DIAGNOSTIC STUDIES OF HIGHWAY VISUAL COMMUNICATION SYSTEMS

STUDY SITE NO. 10

ALASKA STATE HIGHWAY 1 - SEWARD HIGHWAY - ANCHORAGE, ALASKA

TM2(108-10)

Figure 1.

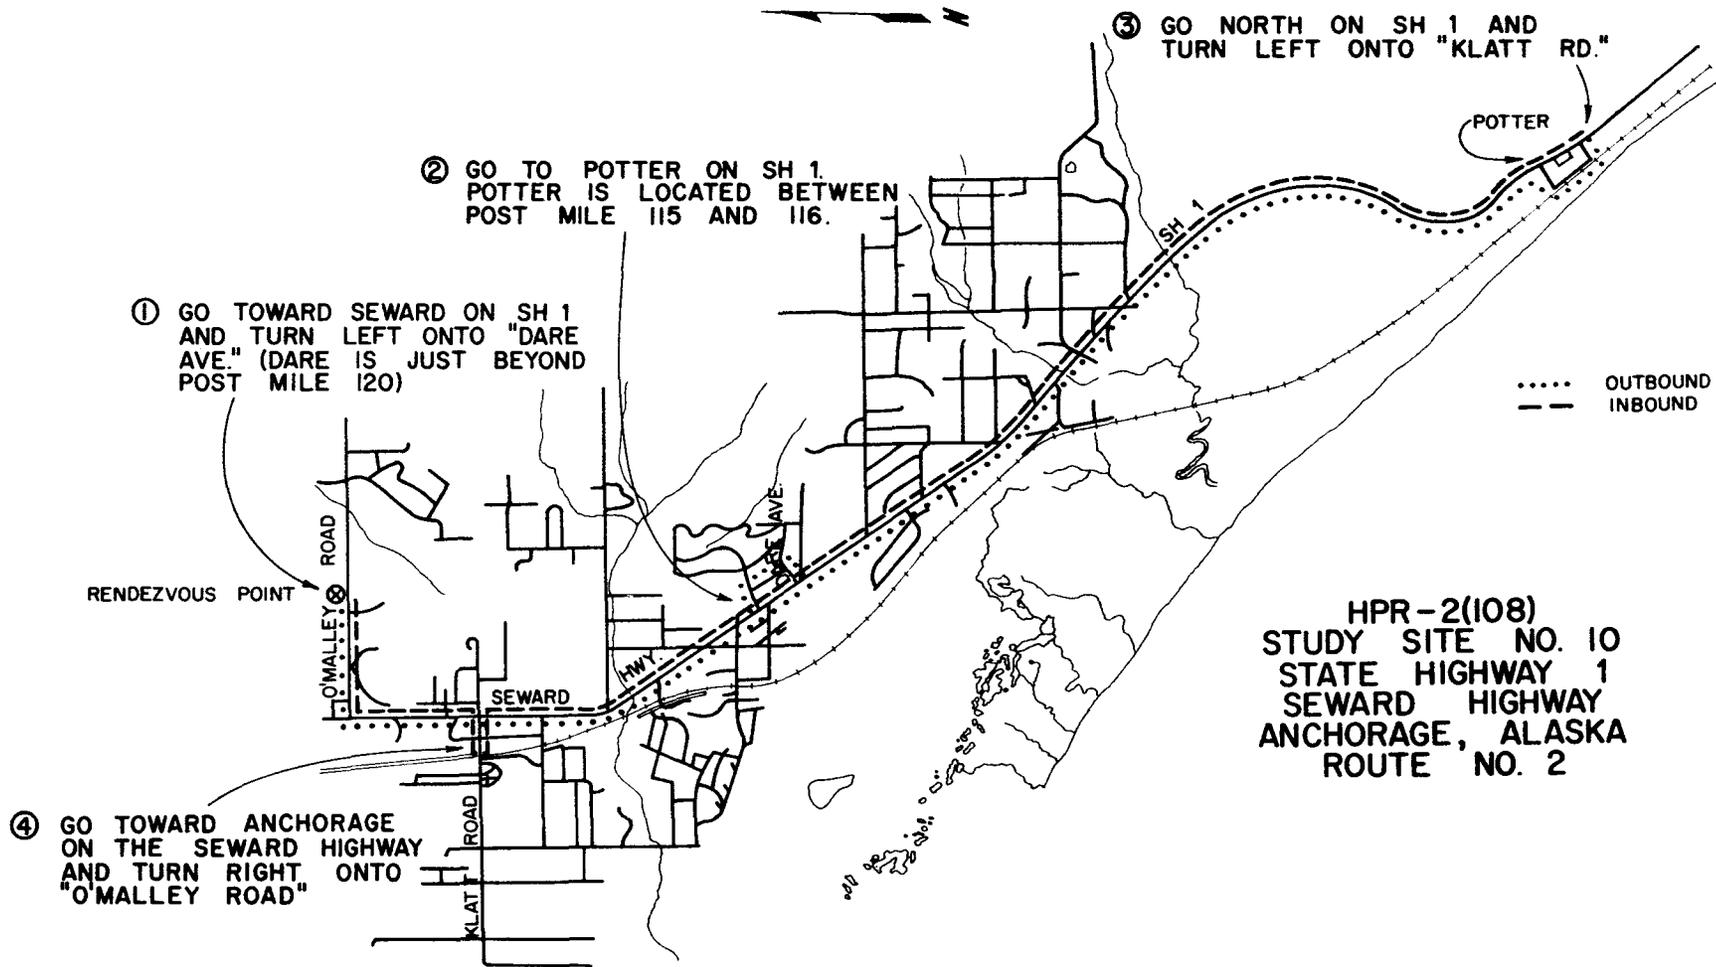
The lack of sight distance just south of the Rabbit Creek Rd. intersection was noted as being one of the critical problems in this area, and it was suggested that some form of control device be added to advise the motorist of a blind hill until it is feasible to reduce the vertical curvature at that point to increase the sight distance.

There was a general consensus of the team that with a narrow shoulder and very sharp side slopes guardrail installation would be desirable. This was particularly true in the area just south of Rabbit Creek Rd. and the Potter turnaround point.

In reviewing the study section for adequate delineation the diagnostic team thought that there were two areas in which it might be desirable to add post-mounted delineators. The first is in the series of curves between Rabbit Creek Rd. and Potter Station which, because of their location within a heavily forested area, were very dark. Thus, it was felt desirable to have delineators on the outside of the curves throughout this section. The other point of discussion regarding delineators dealt with the identification of private driveways into the abutting properties during the winter months. It was a general consensus that it was absolutely essential for these drives to be identified, but there was mixed opinion as to whether this was the responsibility of the property owner or the responsibility of the state. There was no consensus of opinion on the responsibility question; however, it was felt desirable that all the drives should be identified with a common delineator system.
